PLANNING COMMISSION STAFF REPORT

The Southeast Apartment and Retail Building at the Sugar House Loop Conditional Building & Site Design Review PLNPCM2011-00032 2100 South & Highland Drive March 23, 2011

Mecham Management

SITE PLAN

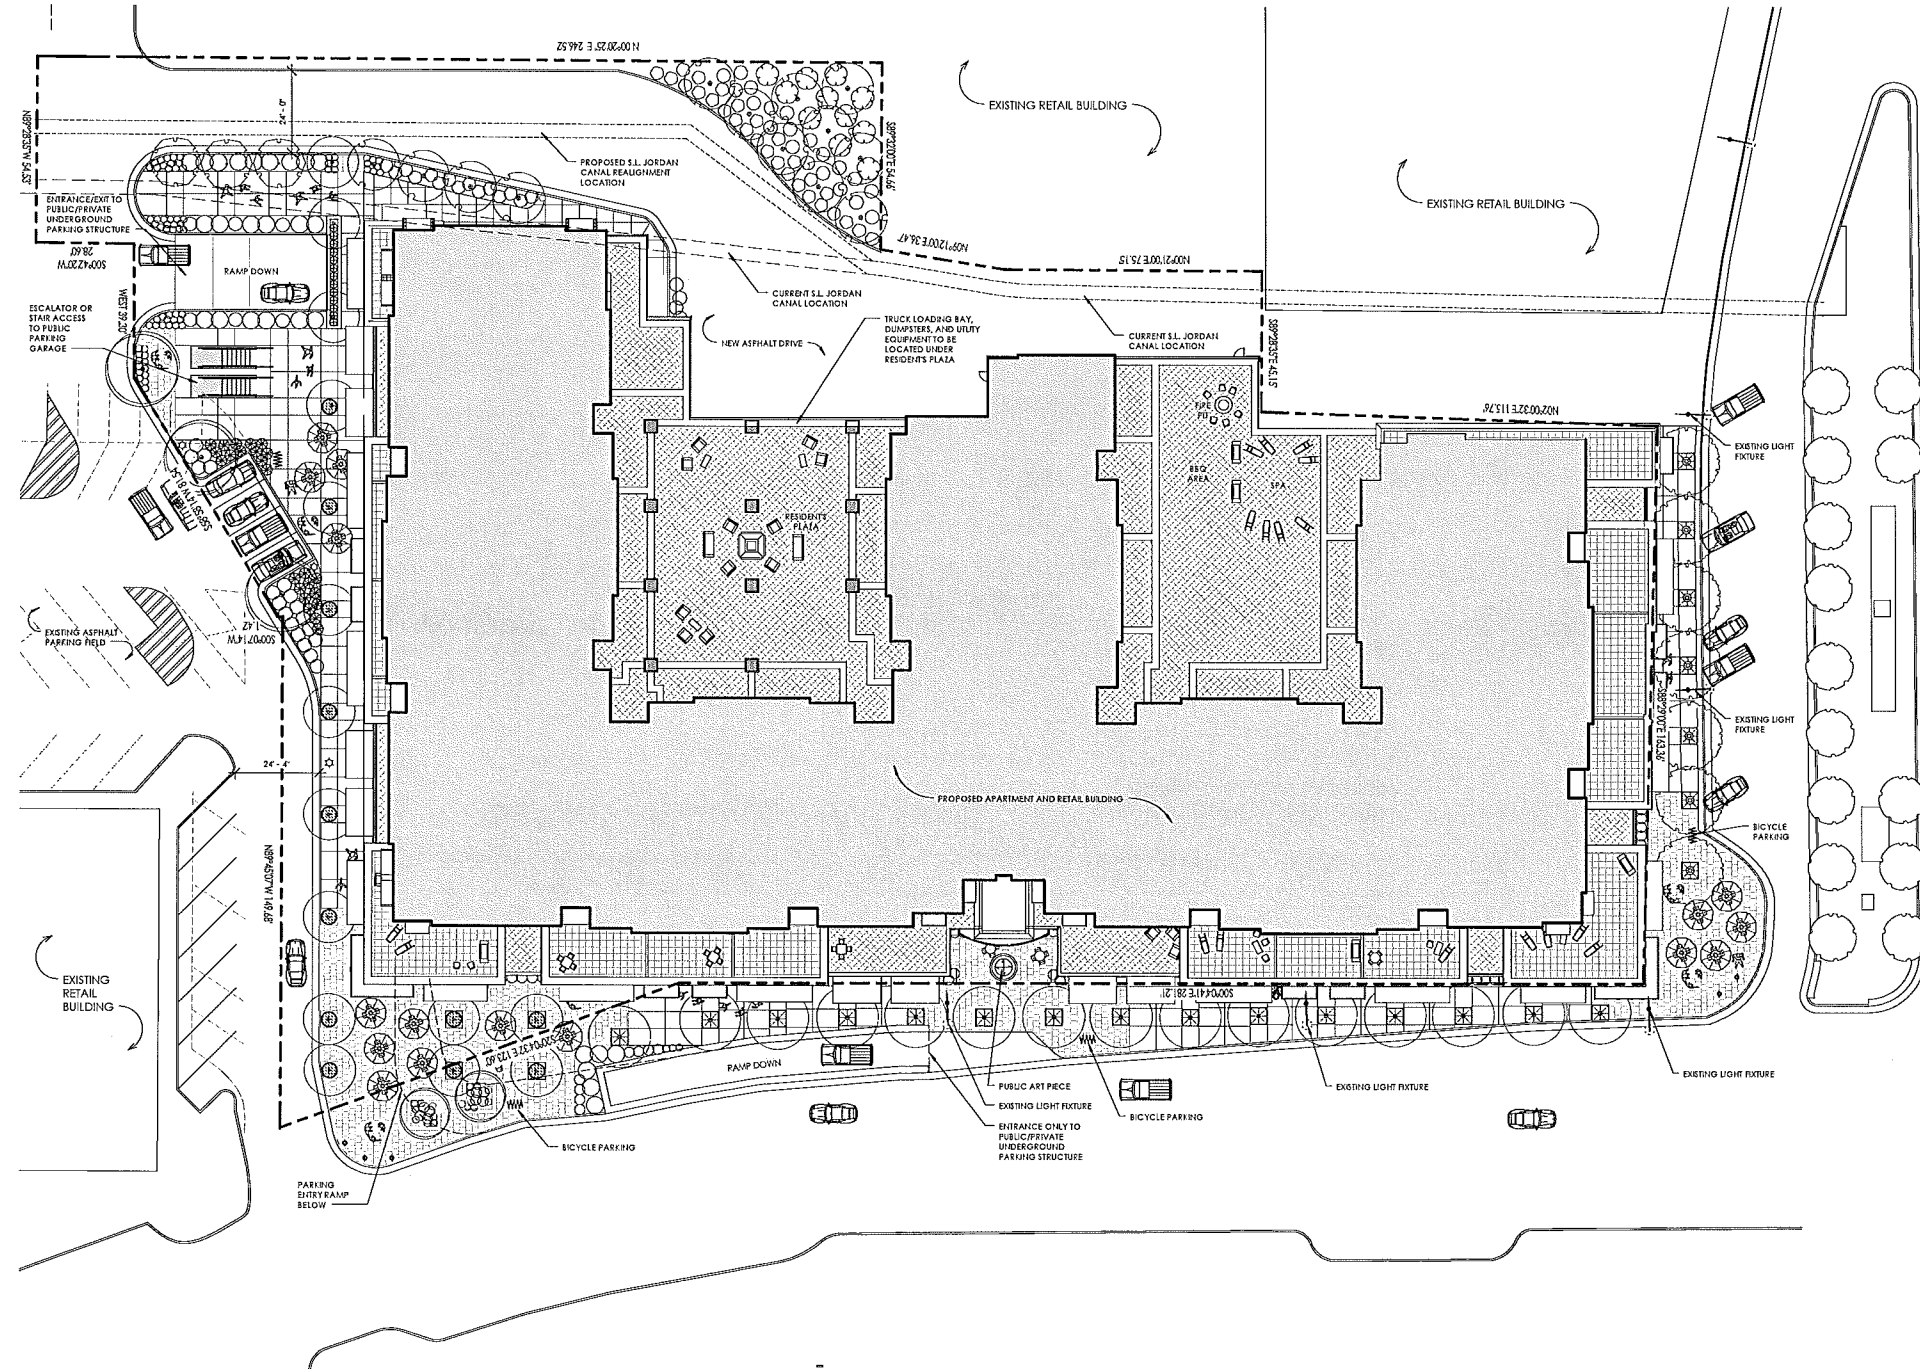
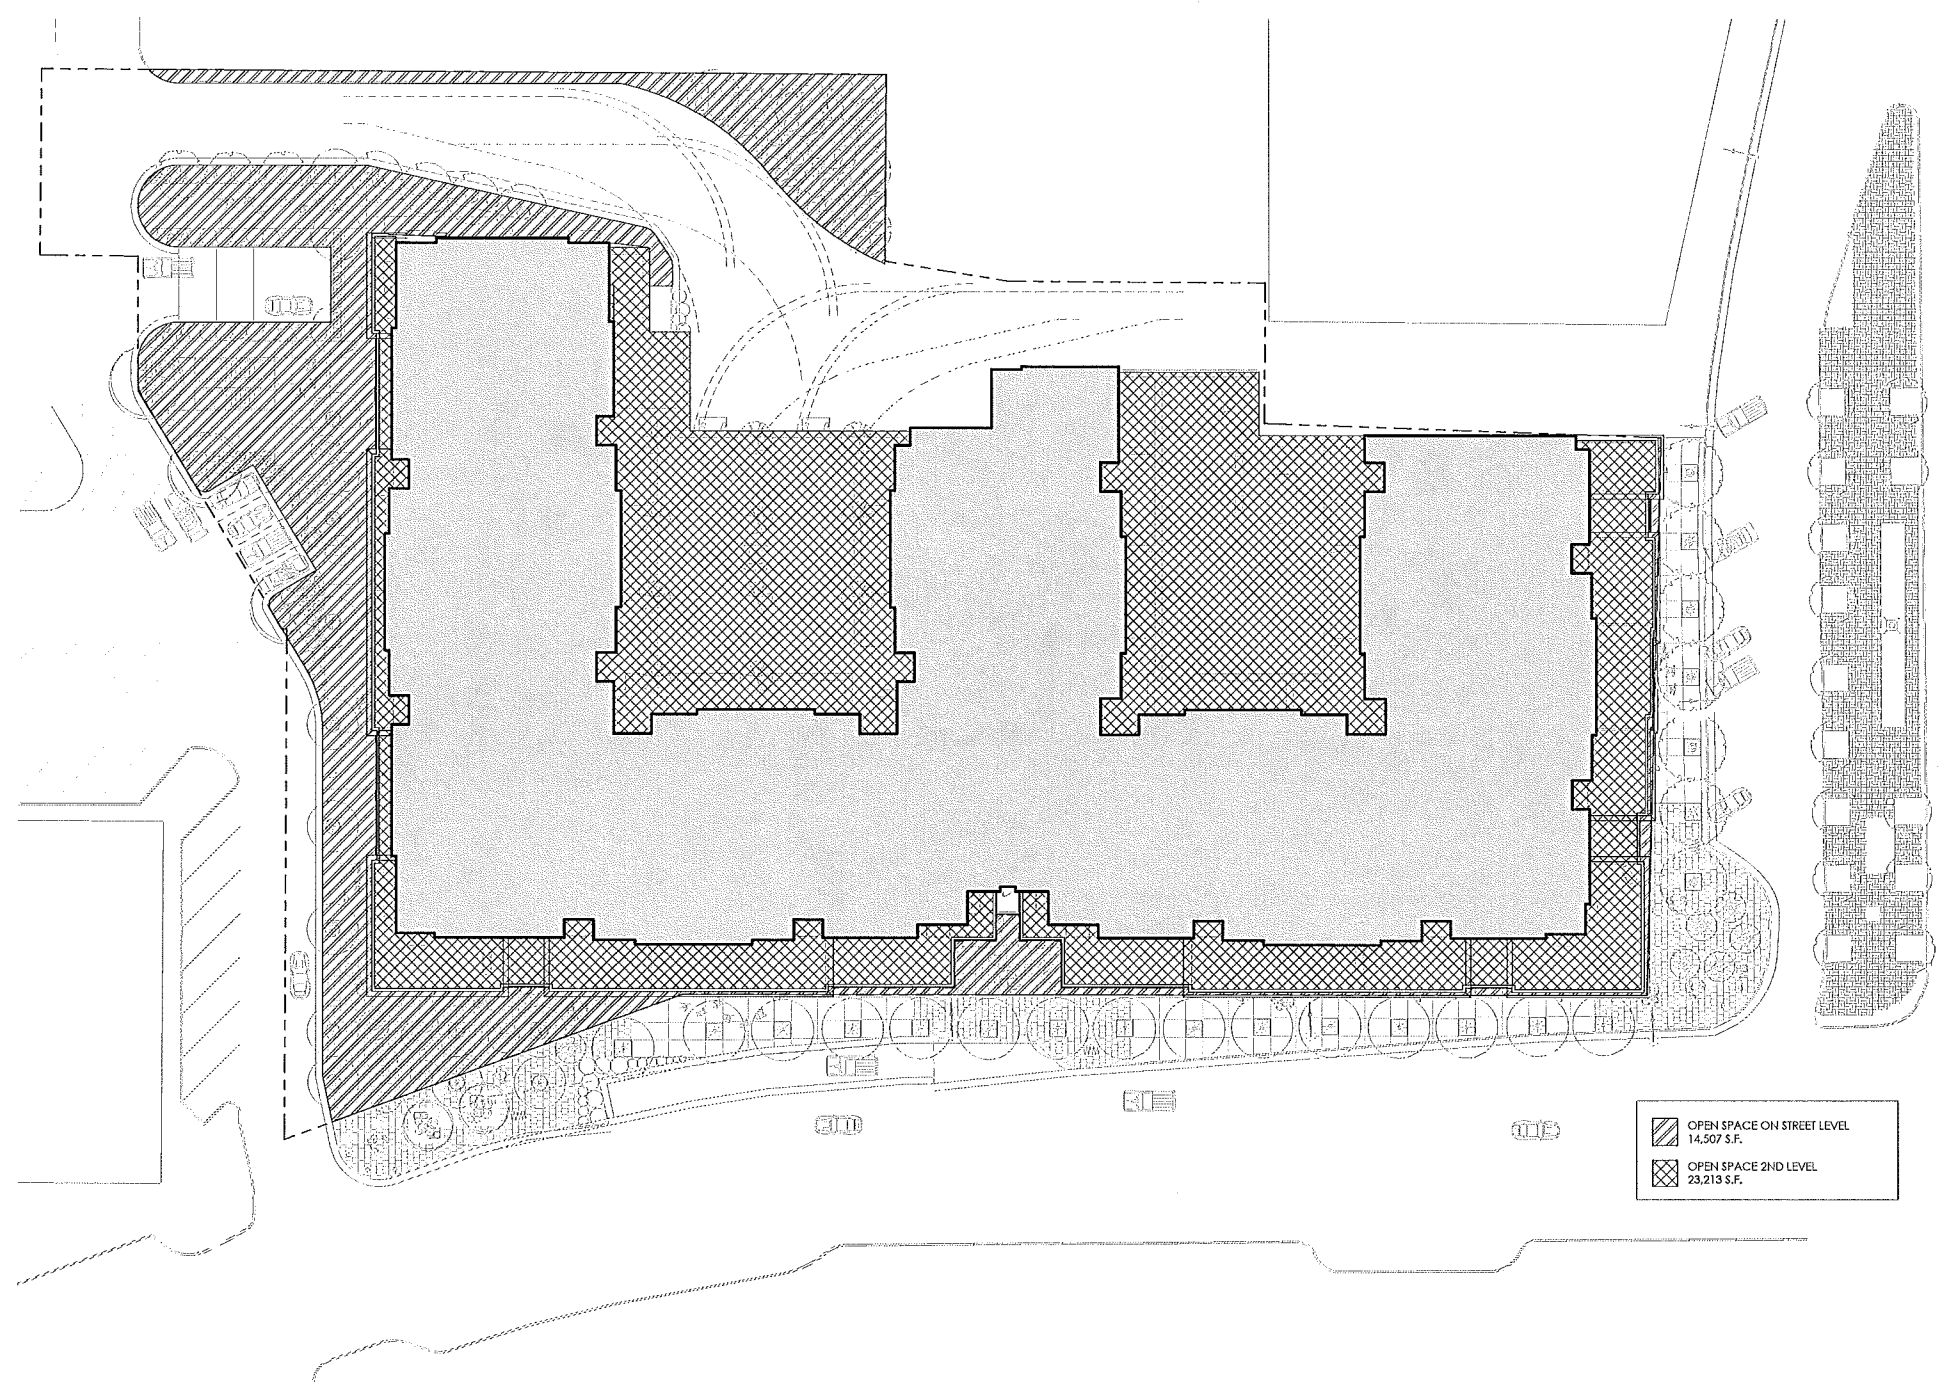
Provide the ADA calculations for the total onsite parking and the 5% bike parking ratio.

Provide the loading dock calculations for number of long and short berths etc.

Revise the highland drive parking structure drive access ramp curb taper for a 15 mph offset with reverse curves.

Provide a continuous pedestrian mid block walkway to the west to align with Elm Street and revise the access drive off Highland to be a "drive approach" with pedestrian priority walkway along Highland to access the future Sugar House Trolley corridor.

LANDSCAPE PLAN
L-L101

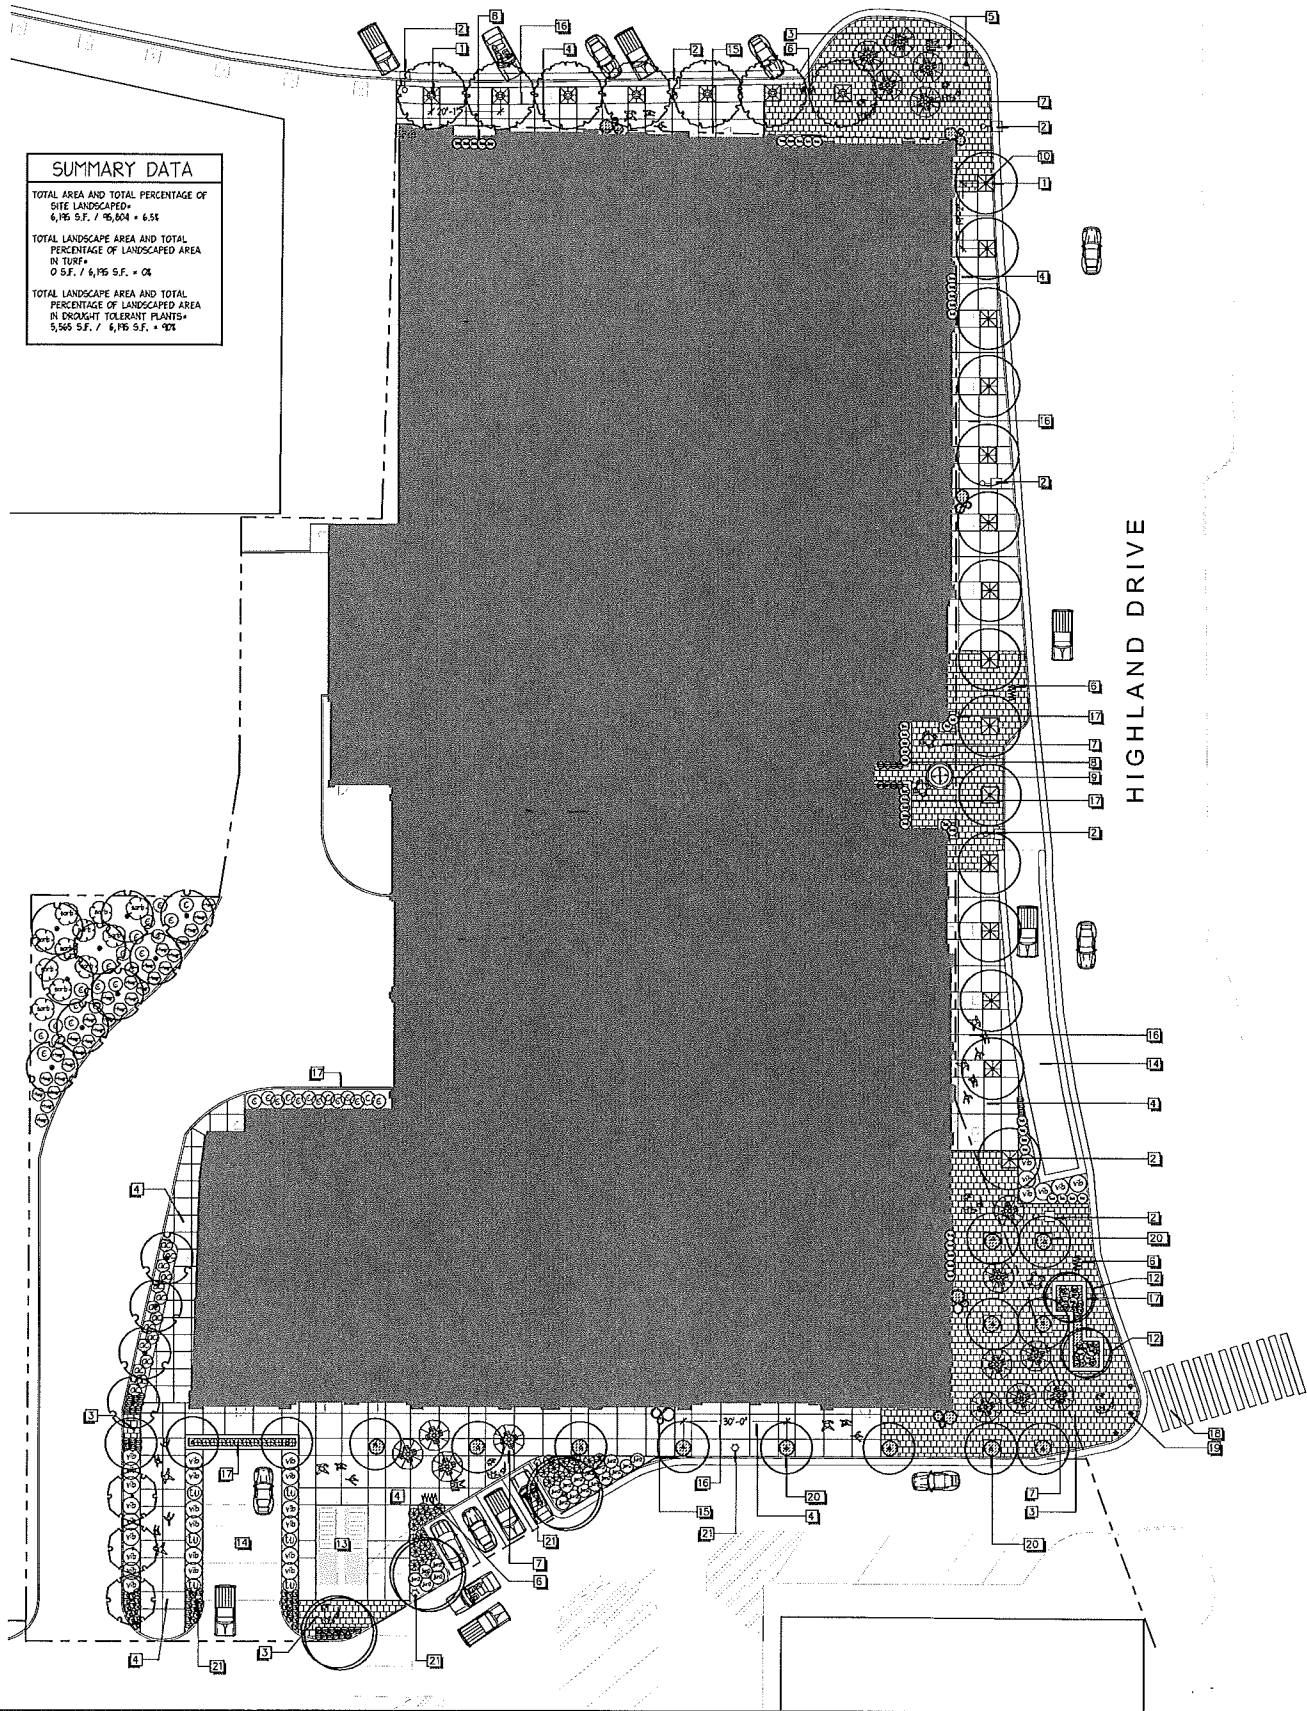
Remove the proposed mid block highland Dr crosswalk shown.
